Retrophone – Whizzbizz.com

Sheet: /
 File: Retrophone.kicad_sch

Rev: 2
 Id: 1/1

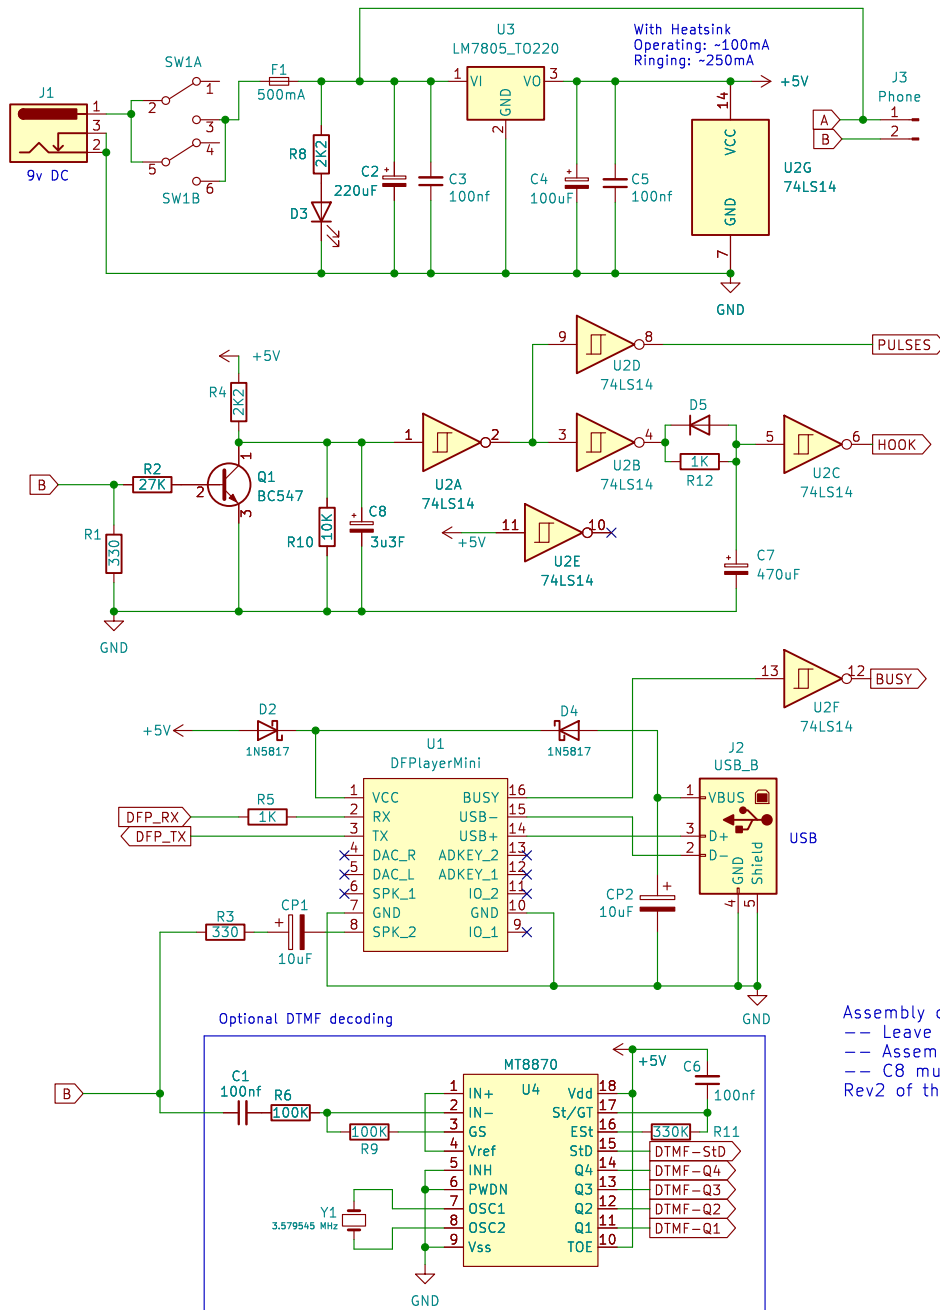
Assembly corrections for Rev1 (July 2023) of the pcb:
 -- Leave out D1 (deleted already in this schematic)
 -- Assemble D5 180 degrees rotated (silk screen error!)
 -- C8 must be soldered manually over R10
 Rev2 of the pcb (marked 'March 2025') was corrected
